CENPD-283-NP-A

Boiling Water Reactor Emergency Core Cooling System Evaluation Model:

Code Sensitivity for SVEA-96 Fuel

SAFETY EVALUATION BY THE OFFICE OF NUCLEAR REACTOR REGULATION
RELATING TO TOPICAL REPORT CENPD-283-P
"BOILING WATER REACTOR EMERGENCY CORE
COOLING SYSTEM EVALUATION MODEL:
CODE SENSITIVITY FOR SVEA-96 FUEL"

Figure A9-7 Core Void Fraction at 20 Seconds versus Core Elevation

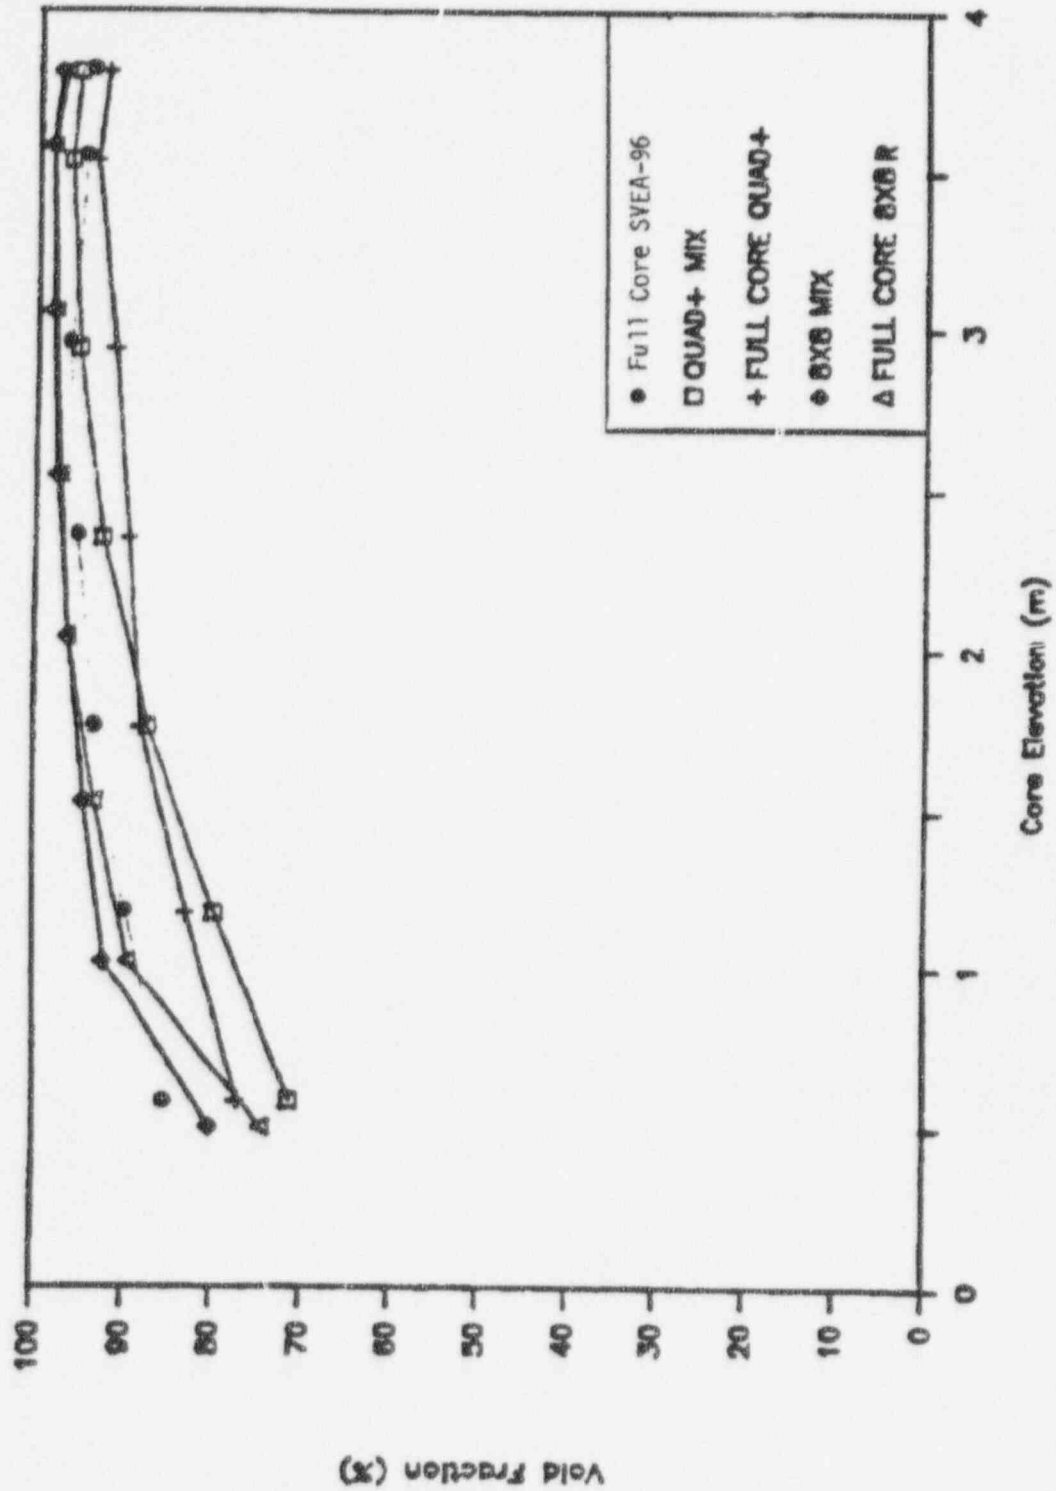
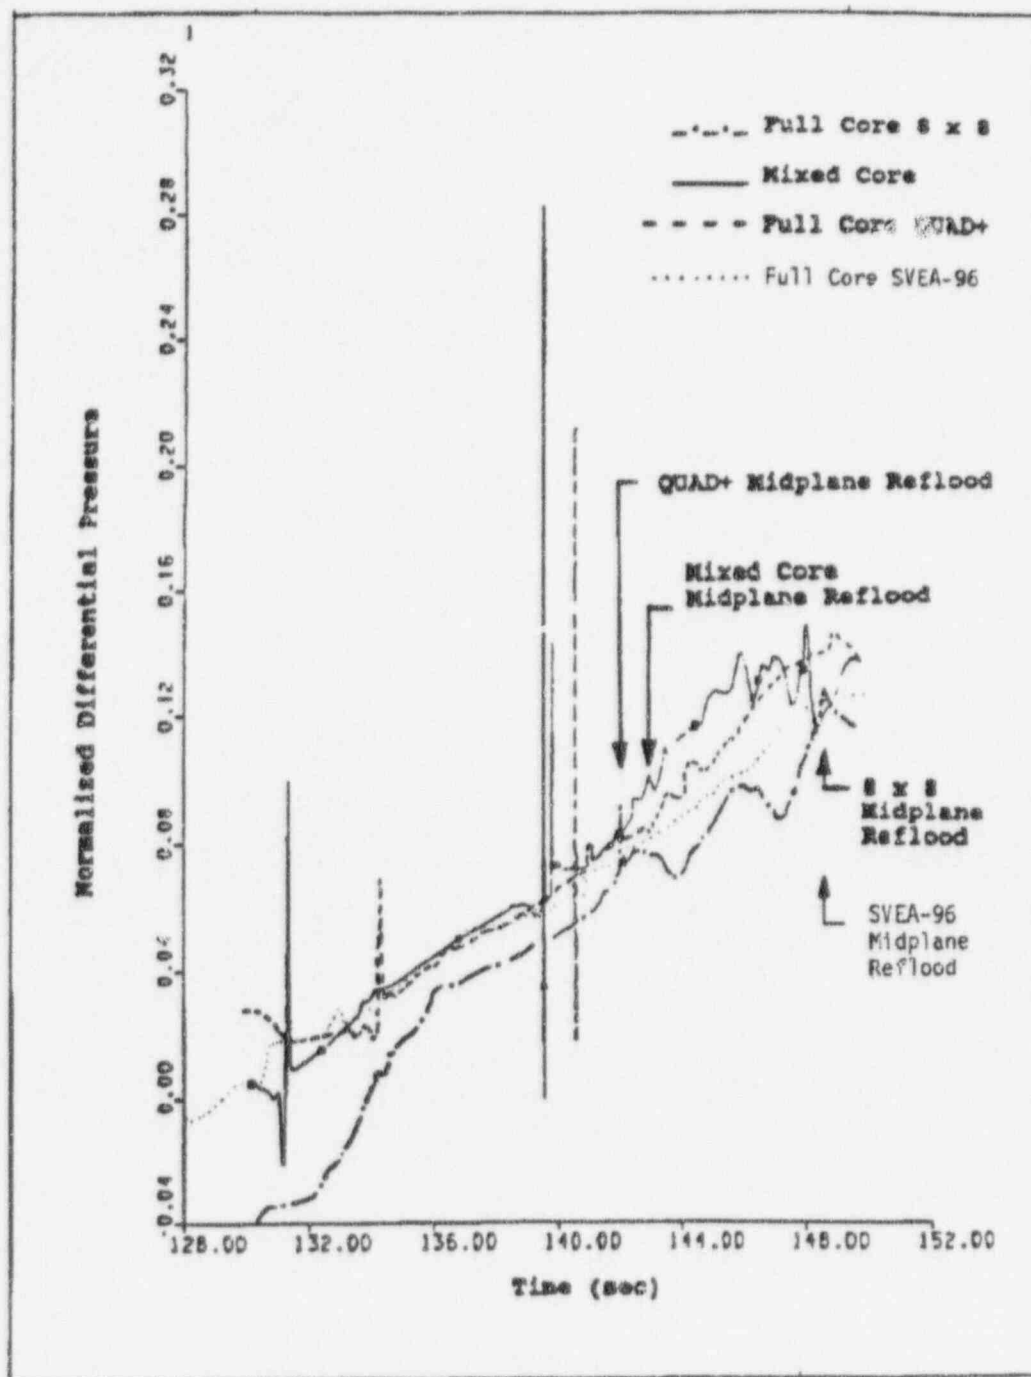
Mixed core effects should be investigated further to support ABB/CE's position regarding the transition cores by presenting mixed core analysis results with transition from QUAD+/SVEA64 fuel to SVEA-96 fuel. The watercross for each fuel design should be explicitly modeled in the nodalization. Provide plots from core void fraction, pressure, flow, and flow velocities.

Reload cores of mixed fuel designs are designed to be hydraulically compatible (See Response A1 of this document). Cores designed to be hydraulically compatible are generically demonstrated in Reference A5, to yield a LOCA reactor system response that is insignificantly altered relative to that of a full core of one fuel design. A full core of one fuel design is used in the LOCA evaluation for that specific fuel design. Hence, the industry accepted process of performing LOCA evaluations for a specific fuel design based on a full core of that fuel design is also valid for mixed core applications.

To further demonstrate that the discussion presented and conclusions drawn in the response to Question 5 of RPB-90-94-P-A are valid in general, the results for a full core of SVEA-96 were compared to the previous system responses in Section 8 of this report. Additional comparative results are shown in Figures A9-1 through A9-8 which correspond to Figures 5-1 through 5-8 on pages 18 through 25 of the Addendum to RPB 90-94-P-A. The core compositions in the four cases presented in Figures A9-1 through A9-8 are:

For the Mixed Core case, as applicable, both QUAD+ and 8x8R channel results are shown in the figure. There are insignificant differences between the system responses of the four cores presented.

As discussed in Response 5 of RPB-90-94-P-A small differences in the responses are attributed to differences in fuel component designs. As noted in Response A1 of this document, the SVEA-96 core used as an example was not specifically designed to be hydraulically comparable with the previous example cores (i.e., QUAD+ and 8x8). Hence, in some instances in Figures A9-1 through A9-8, the SVEA-96 results deviated slightly more than those observed for the other cores configurations. However, the overall system responses are very similar.

The results presented here further substantiate the general conclusion that the core average system response is relatively independent of local differences in fuel assembly design.
